Re: Former Chevron Service Station # 9-5630, 997 Grant Avenue, San Lorenzo, California (the "Property"); Independent Professional Analysis of Chevron's Investigation and Remediation Work to Date

SUMMARY OF INVESTIGATIONS AT FORMER CHEVRON SERVICE STATION 9-5630 AT 997 GRANT AVENUE IN SAN LORENZO, CALIFORNIA

JOB NUMBER 04-0116502-000

RESULTS OF REVIEW OF REPORTS REGARDING FORMER CHEVRON SERVICE STATION 9-5630, LOCATED AT 997 GRANT AVENUE, SAN LORENZO, CALIFORNIA

FIGURE 2
SOIL EXCAVATION SAMPLE RESULTS
FORMER CHEVRON SERVICE STATION
997 GRANT AVENUE
SAN LORENZO, CALIFORNIA

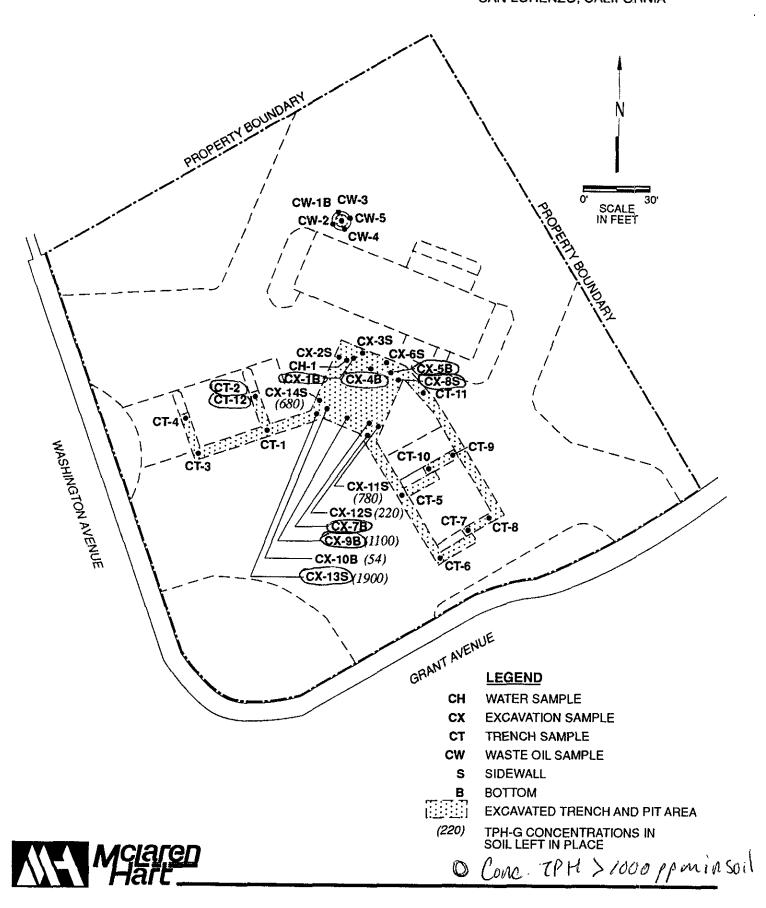
- 1. Soil with very high levels of TPH-G has apparently been left in place (see Figure 2, locating soil samples left in place with 54 ppm, 220 ppm, 680 ppm, 780 ppm, 1100 ppm and 1900 ppm TPH-G);

in the two GeoStrategies Inc. reports indicates that soil was left in place which contains concentrations of total petroleum hydrocarbons as gasoline greater than 10 ppm, and future remedial investigation may be required by regulatory agencies. Figure 2 presents the results of soil samples collected following excavation and identifies areas where concentrations of TPH-G in soil greater than 10 ppm remain in place.

The inability to collect groundwater samples from monitoring well C-4 remains a concern, since this well is located in the area where the highest concentrations of TPH-G were detected during drilling. Soil excavation during tank removal did remove much of the soils in the vicinity of well C-4, but the excavation was terminated prior to the removal of all soil containing TPH-G concentrations greater than 10 ppm.

- Soils remain in place which contain greater than 10 parts per million (ppm) total petroleum hydrocarbons as gasoline (TPH-G), and in some locations, soils containing TPH-G concentrations in excess of 100 ppm remain in place. Regional Water Quality Control Board and Alameda County Health Services, Environmental Health Division recommend that soils containing greater than 10 ppm TPH-G be removed or remediated. McLaren/Hart believes that the areas which contain soil TPH-G concentrations greater than 10 ppm must be further assessed and remediated by Chevron USA.

FIGURE 3
HISTORICAL GROUNDWATER ANALYTICAL DATA
FORMER CHEVRON SERVICE STATION 9-5630
997 GRANT AVENUE
SAN LORENZO, CALIFORNIA

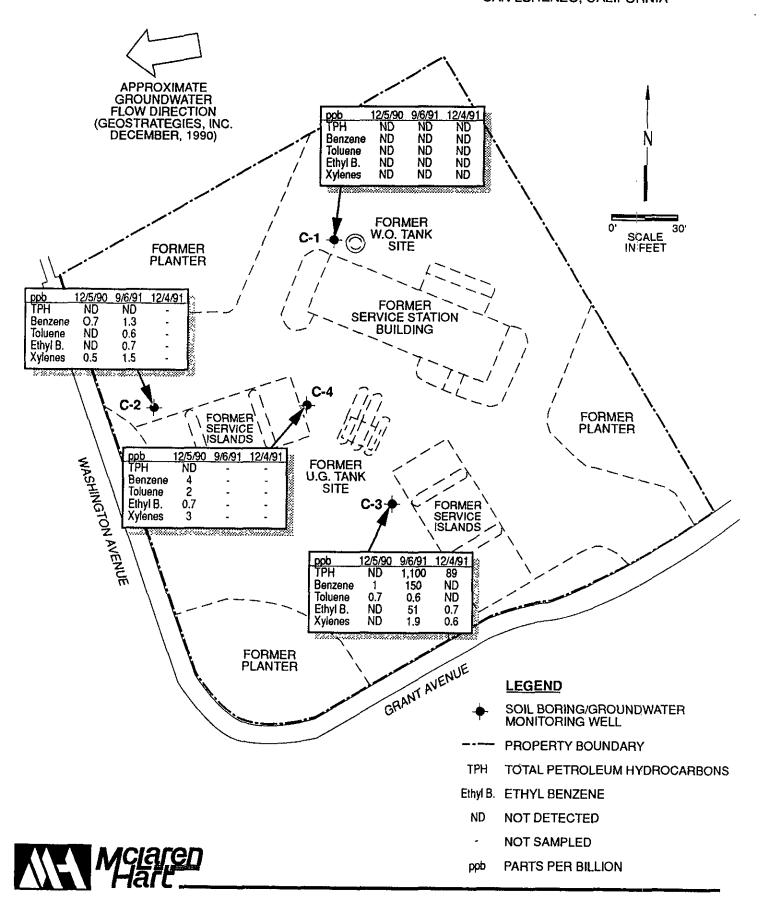
The concentrations of TPH-G (or TPPH-G) and BTEX compounds in groundwater have varied considerably in the three groundwater sampling events conducted to date. TPPH-G and benzene concentrations have varied in well C-3 from below the detection limit of 50 ppb for TPPH-G and 0.5 ppb for benzene, to detected concentrations of 1,100 ppb and 150 ppb, respectively. Historical groundwater analytical results are presented in Figure 3. The current State Department of Health Services (DHS) regulated Maximum Contaminant Level of benzene in groundwater is 1 ppb, and regulators generally aim to have site groundwater contamination defined to non-detectable levels of TPPH-G.

The groundwater flow direction beneath the site was reported to be to the west in the December 1990 sampling event, to the northeast in the September 1991 sampling, and again to the northeast in the December 1991 sampling. Review of the topographic map of the area (U.S.G.S.; San Leandro, California, 7.5 Minute Quadrangle) indicates the ground surface slopes to the west/southwest in the vicinity of the site, and therefore groundwater flow to the northeast would be topographically uphill, and not likely. Shallow groundwater flow generally follows surface slope. Review of the Sierra Environmental Services sampling data shows that the depth to water elevations are referenced to the top of casing (TOC) and not to the top of box (TOB). The elevations surveyed by GeoStrategies, Inc. were to the top of the christy box, and not to the top of the casing. Since the distance between the top of the casing and the top of the box may range from 0.2 to 0.8 feet, it appears that Sierra Environmental Services has been mistakenly using an unsurveyed portion of the well to determine groundwater elevations. The direction of groundwater flow must be determined to 1) understand the hydrologic system in the vicinity of the site, 2) define the direction of chemical migration, and 3) correctly place future monitoring wells downgradient of the source areas. If the Christy boxes had been damaged or disturbed during site excavation activities, it would be necessary to return to the site and resurvey the well elevations.

The determination of the groundwater flow direction is necessary to evaluate whether groundwater contamination has migrated downgradient of the source areas and possibly offsite. Existing groundwater analytical data is limited, and does not allow for determination of the extent of petroleum hydrocarbon contamination. The installation of additional monitoring wells in the verified downgradient direction is necessary to determine whether petroleum hydrocarbons have migrated from the source areas.

- Shallow groundwater flow direction at the site was reported to be to the west in December 1990, but to the northeast in September 1991 and December 1991. A groundwater flow direction to the northeast seems unlikely since that would be topographically uphill. It appears that the groundwater elevation data collected in September and December 1991 is erroneous due to the use of the wrong reference datum. Groundwater flow direction must be better defined to ensure that the contaminant plume is adequately defined in the downgradient direction. The influence of tidal fluctuation on groundwater elevations and flow direction at the site should also be evaluated. The installation of additional groundwater monitoring wells and the resurveying of new and existing wells at the site would achieve this objective.
